## WADE ONE AND NOBLE GAS SYSTEMS JSP24-05

### **JSP24-05 Wade One and Noble Gas**

Public Hearing at the request of Integrity Building Group for a Special Land Use Permit and Preliminary Site Plan. The subject property, 45241 Grand River Avenue, is an approximately 29,000 square foot building on a 7.61 acre parcel within the I-1 Light Industrial Zoning District. The site is located south of Grand River Avenue and east of Taft Road. The applicant is proposing to operate two separate businesses out of an existing industrial building. Wade One is a company that manufactures stone-cutting equipment and Noble Gas Systems tests air tanks for leaks and pressure.

Sheet Number: **C2.10**

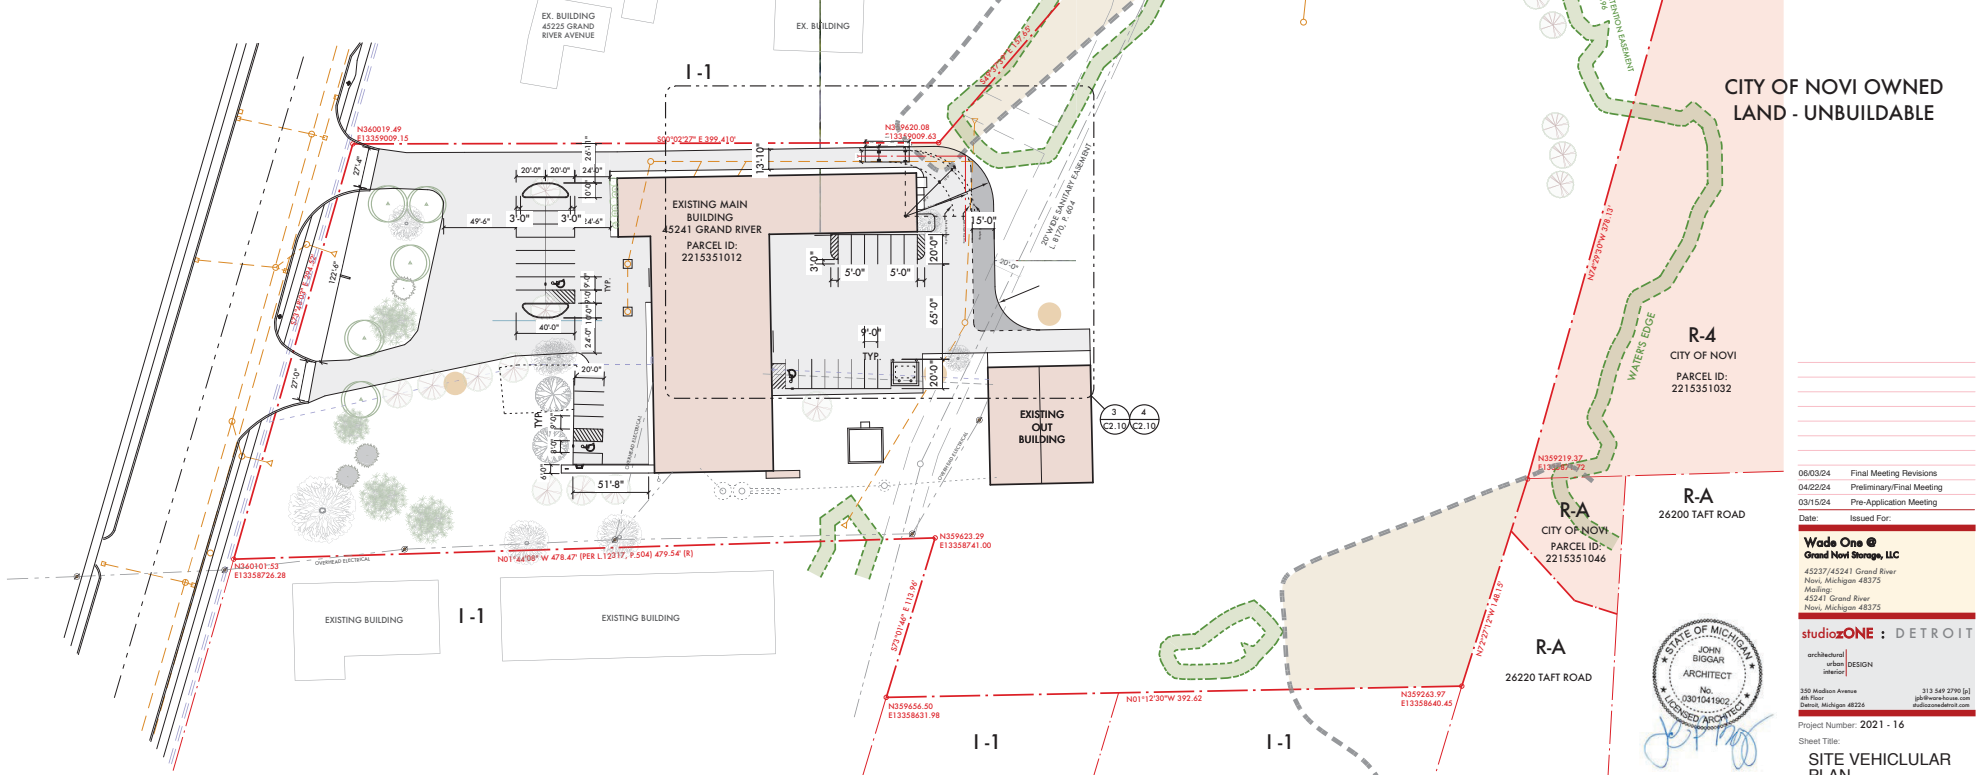
6. At the pre-application meeting, it was discussed that the 6" sump was removed. Additionally, the checklist comments also mention its removal. However, it is still shown on C2.10/11/14. Please revise these sheets to reflect if the sump is still in place or not.

Sheet Number:  
**C2.11**

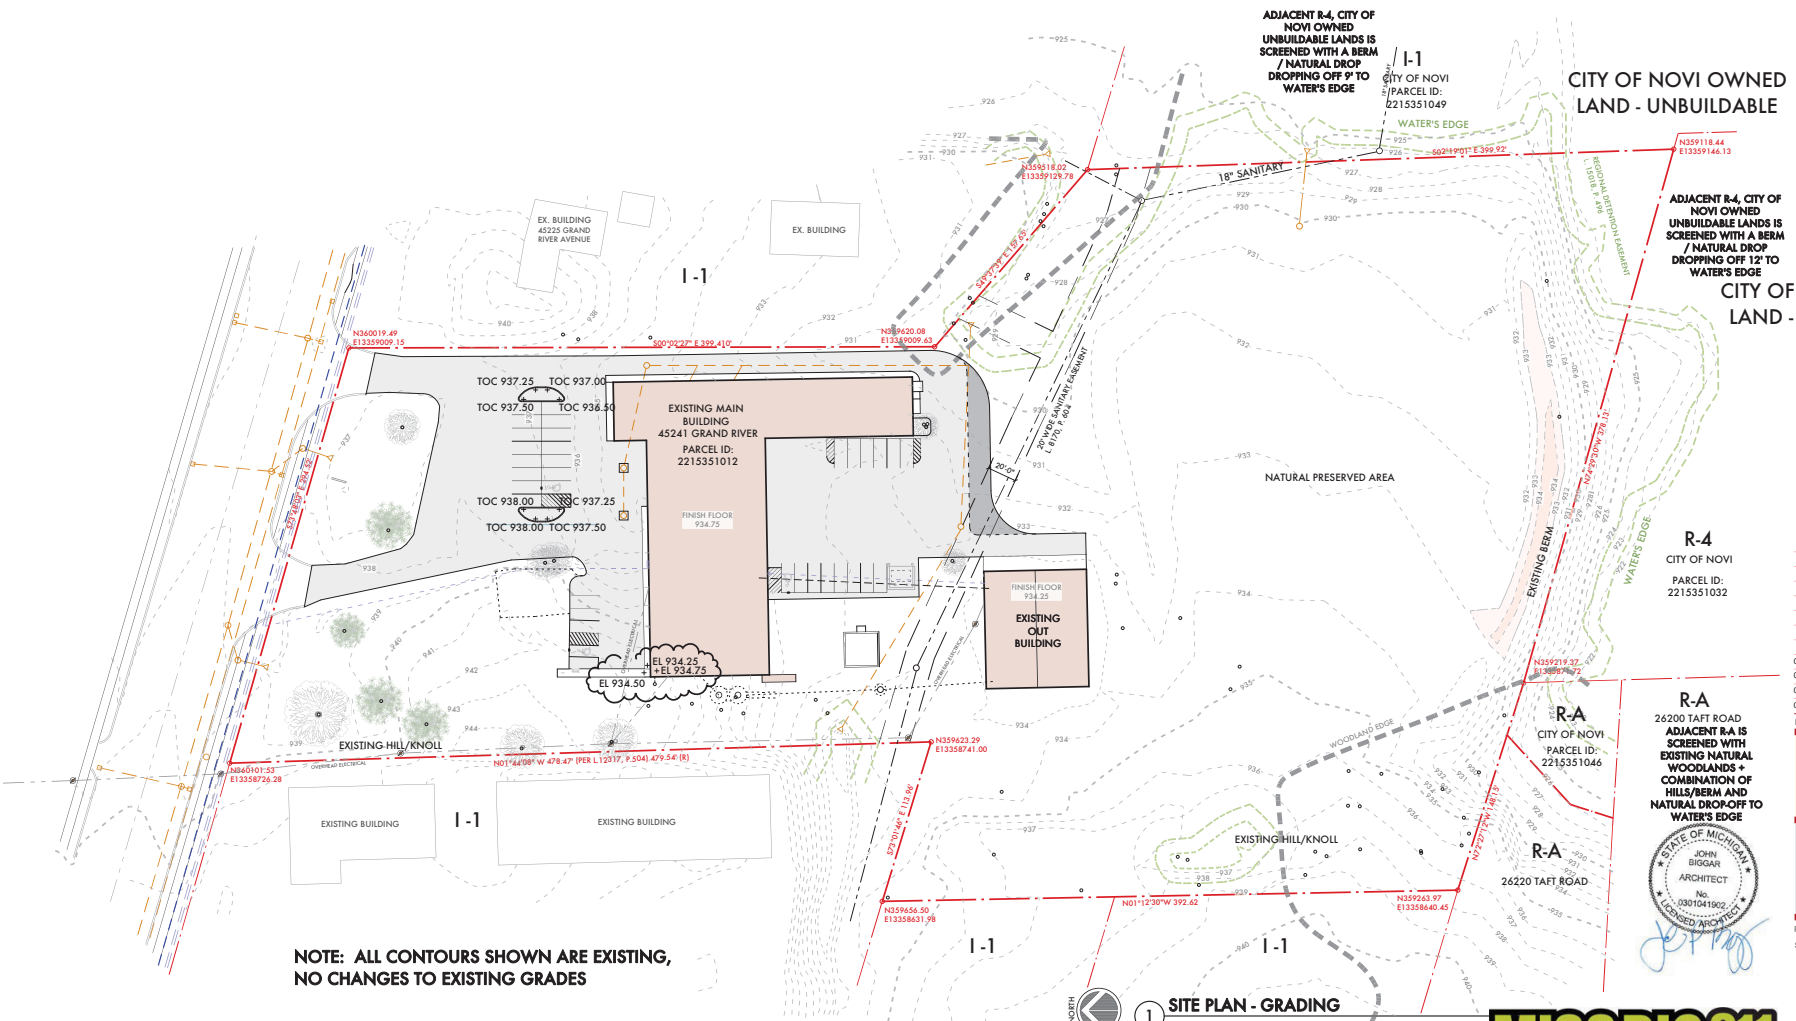
- a. Only add proposed materials to the C2.11 table; include sidewalk, concrete pad, and end islands
  - b. Concrete pad plan view detail still shows 6" slab instead of 8"; section view is correct with the 8" on 8" though

- c. Add note on C2.11 that end islands are proposed  
Show top of pavement spot elevations alongside the toc elevations to ensure 6" curb around the end islands

- e. Only include proposed signs in the C2.11 signing table
  - f. No NPDES permit needed
- b. Landscape Review: Landscape recommended approval of the combined Preliminary and Final Site Plan, contingent on the applicant making the necessary correction as stated in the Landscape review letter to remove the one unsupported waiver. **Please be sure to review the previous Landscape review letter and address the unsupported waiver in your response letter and on the Electronic Stamping Set.**

- a. Proposed Materials – Added sidewalk, concrete pad and end islands
- b. Concrete Pad – Detail 2/A2.60 updated to 8” concrete pad
- c. End Islands – Note 16 adding indicating the curbs and end islands are new. The spot elevations are shown on the Grading Plan C2.12.
- d. ADA Sidewalk Elevations – Note “The proposed sidewalk shall meet existing elevations/grades and ADA standards where they meet” is added to drawing C2.11 Layout Plan and C2.12 Grading Plan.
- e. Signing Table – Only signs being used are in the table. Graphic symbols of the (3) signs added to drawing C2.11

- All proposed barrier free signs are shown on C2.11 Layout Plan and on the details on drawing C2.61.

- Signing Table – Only signs being used are in the table. Graphic symbols of the (3) signs added to drawing C2.11. Only (2) R7-8A Van Accessible signs are being provided.

Sheet Number: L2.10

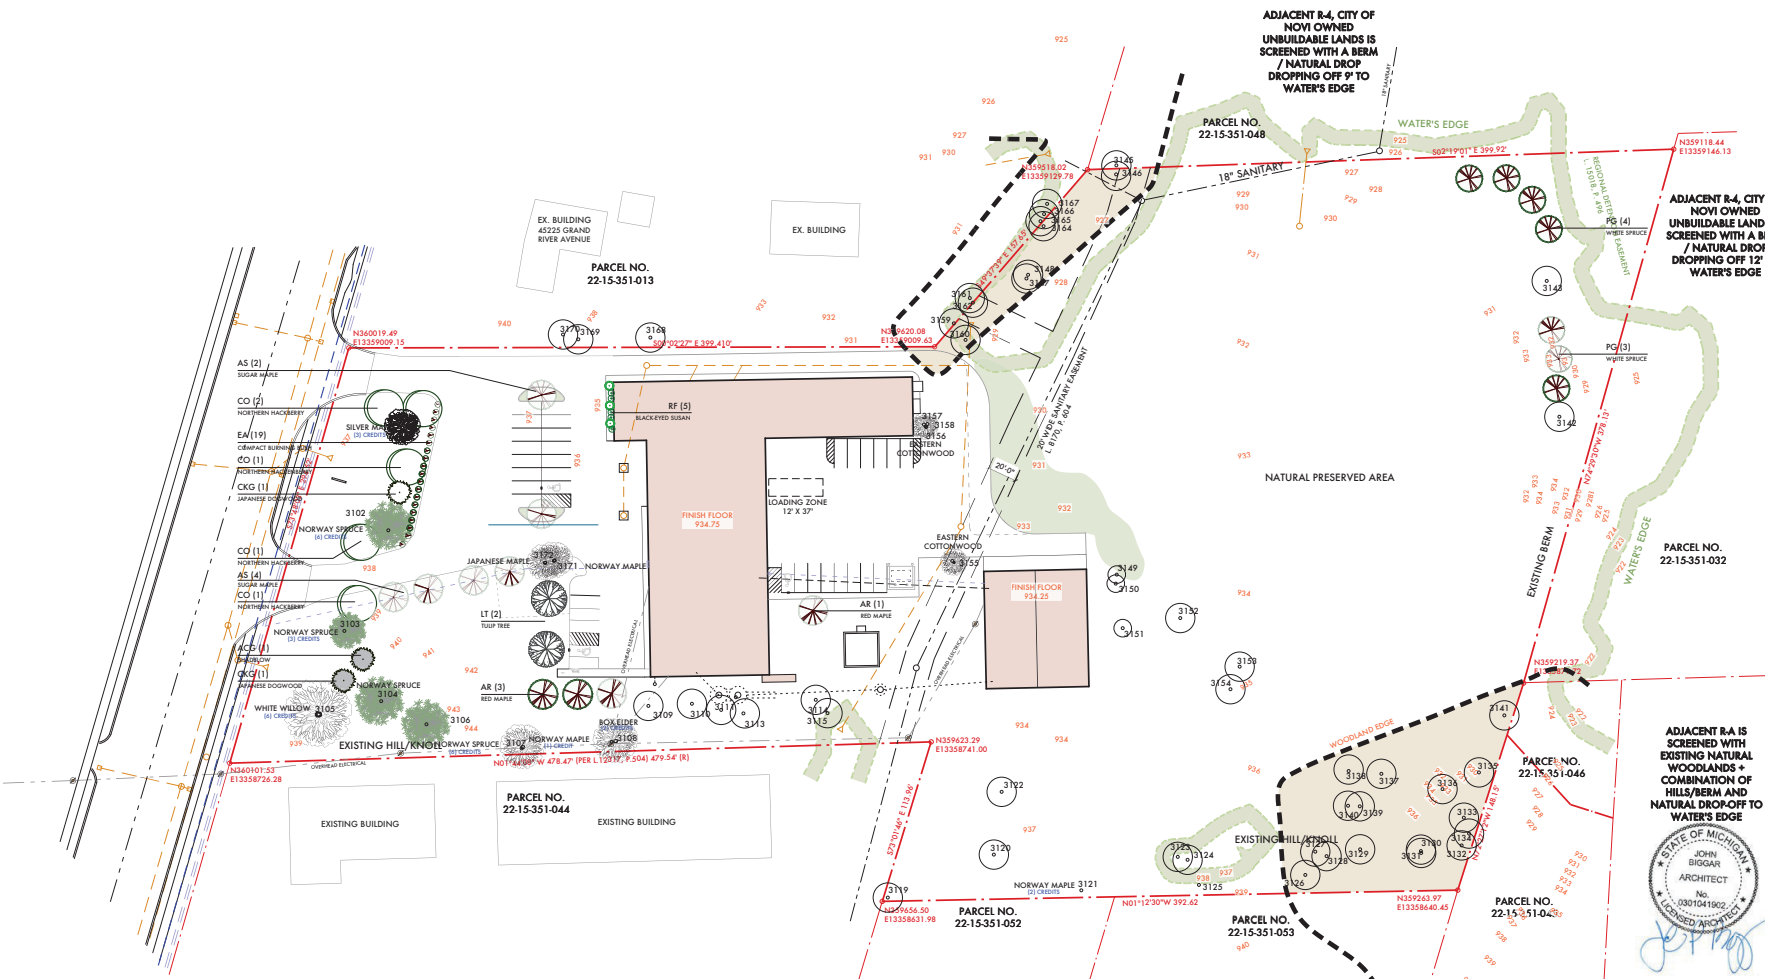
- e. Contingent on the applicant correcting the plans to remove the **unsupported waiver** for deficiency in in parking lot perimeter trees by planting two canopy trees on the south side of the building, outside of the sanitary easement;

Please note: We have added (4) additional red maple trees at the perimeter trees. From the original concept meeting we were told with the additional trees further south on the property that we are providing that no additional trees would be required around the rear parking area. We have added additional trees as requested by this Planning Review letter, see L2.11 Landscape Plan.

- An additional (4) additional perimeter trees have been added, see L2.11 Landscape Plan

**Attachment A  
Site Photographs**

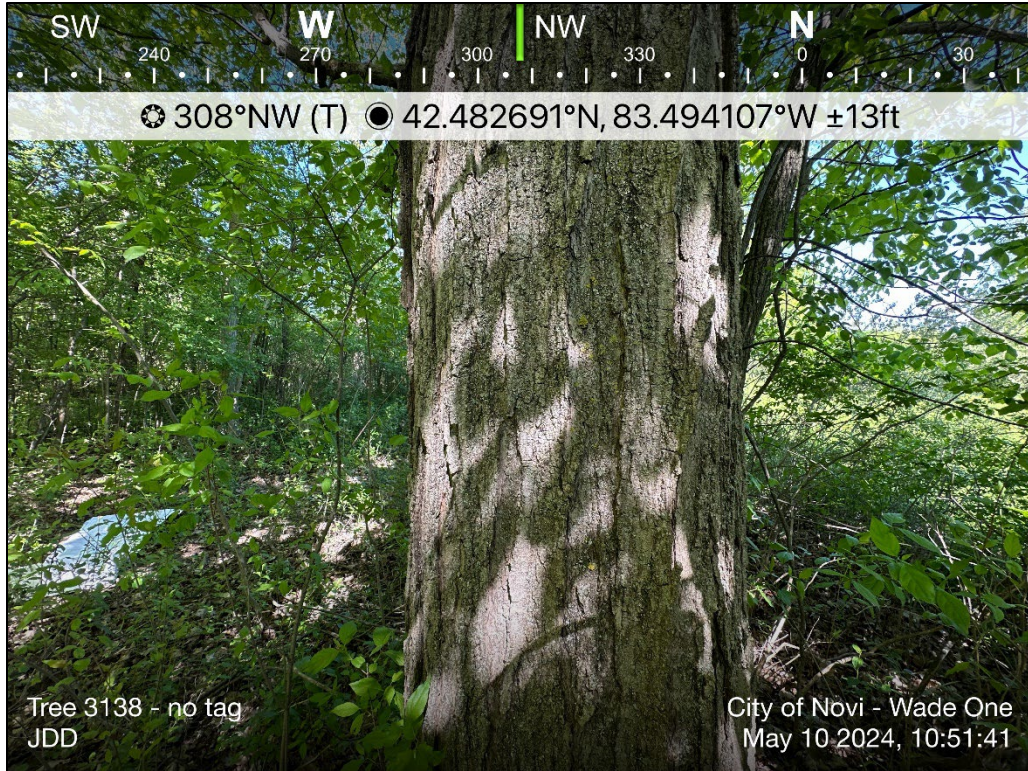
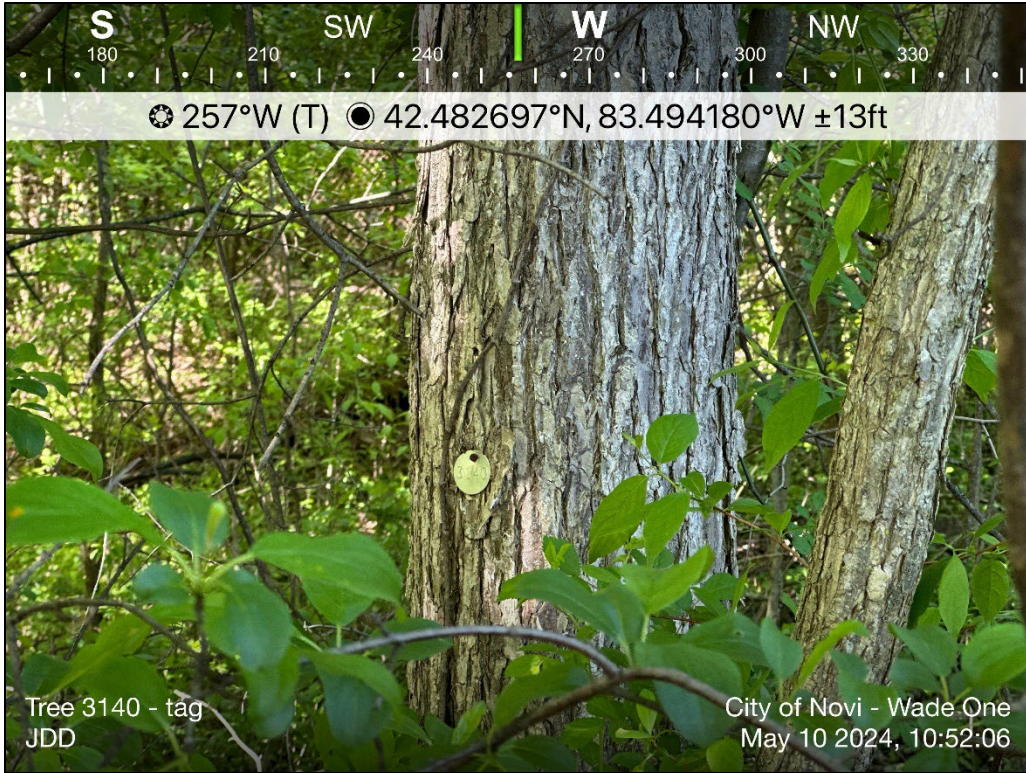
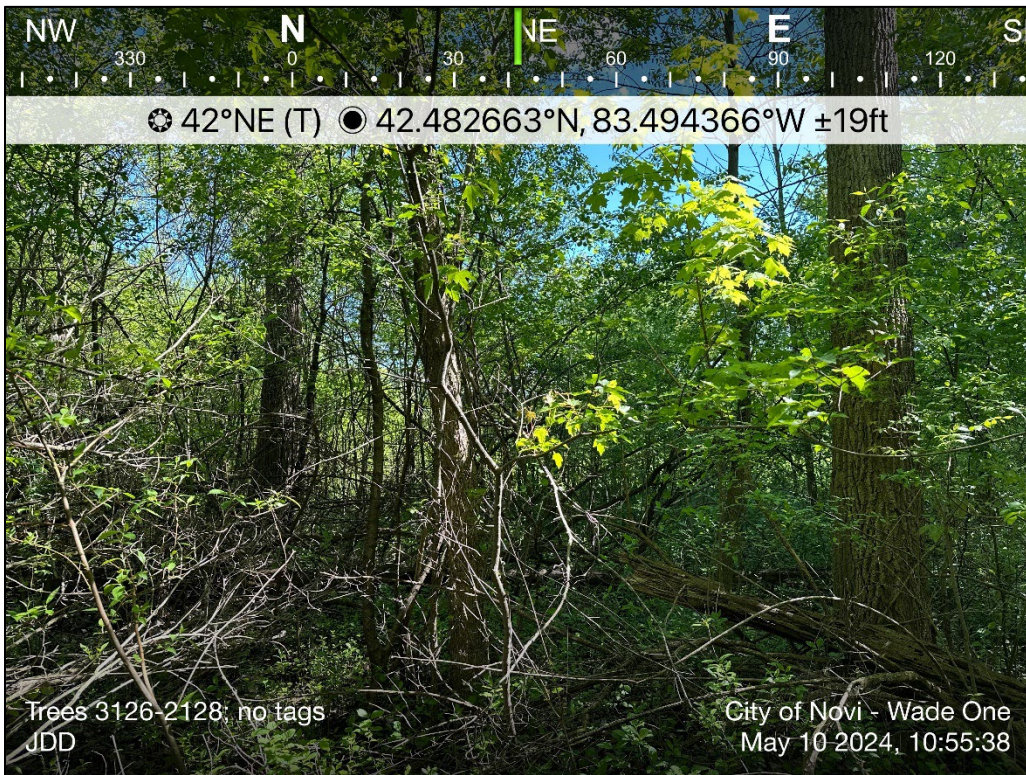
Approximate location of Tree 3138 with no tree tag identified on-site. Tree is identified as having a DBH of 17 in the site plans but was found to be closer to 21.7 inches DBH.

Trees 3126-3128 all contained no tree tags.

Tree 3137 contained no tree tag. Site plans identified tree as being 11 inches DBH but on-site inspection revealed tree is closer to 13 inches DBH.
